# Access Compliance Report

## Public Rights-of-Way

### (Curb Ramps)

Intersection ID: 5704	Main Street: W_W_T_HARRIS_BV	Cross Street: N_TRYON_ST	Location: S
ADA ID: 90711ECF68F3	Ramp Type: Perp	Initial Pass/Fail: Fail	Overall Compliance: No
Severity Score: 12.5			
Codes/Mitigation Info/Possible Solution		Field Measurements/Component Compliance

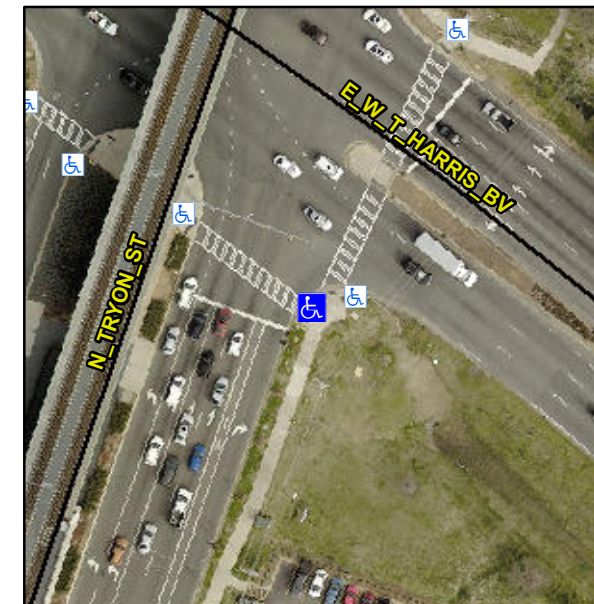
**Remove & Replace Entire Ramp.**

**Not Found, R304.2.2**

Compliance	Description	Data	Compliance	Description	Data
N/A	Ramp Length (in)	96.0	No	Ramp Slope (%)	9.2
Yes	Ramp Width (in)	48.0	Yes	Ramp XSlope (%)	0.4
N/A	Flare Type LT	N/A	N/A	Flare Type RT	N/A
N/A	Flare Slope LT (%)	N/A	N/A	Flare Slope RT (%)	N/A
N/A	Flare Traversable LT?	N/A	N/A	Flare Traversable RT?	N/A
N/A	Landing Length (in)	N/A	N/A	DWS Provided?	N/A
N/A	Landing Width (in)	N/A	N/A	DWS Contrast?	N/A
N/A	Landing Slope (%)	N/A	N/A	DWS Length (in)	N/A
N/A	Landing X Slope (%)	N/A	N/A	DWS Full Width?	N/A
N/A	Landing Curb? (Y/N)	N/A	N/A	DWS Offset (in)	N/A
N/A	Shared Landing?	N/A			
N/A	Gutter Ponding?	N/A	N/A	Gutter Slope (%)	N/A
N/A	Gutter Lip Ht (in)	1.5	N/A	Gutter X Slope (%)	N/A
N/A	Painted X Walk1?	No	N/A	Painted X Walk2?	N/A
	X Walk 1 Direction	To NW		X Walk 2 Direction	N/A
N/A	X Walk 1 Width (in)	N/A	N/A	X Walk 2 Width (in)	N/A
	X Walk 1 Slope (%)	0.6		X Walk 2 Slope (%)	N/A
	X Walk 1 X Slope (%)	0.9		X Walk 2 X Slope (%)	N/A
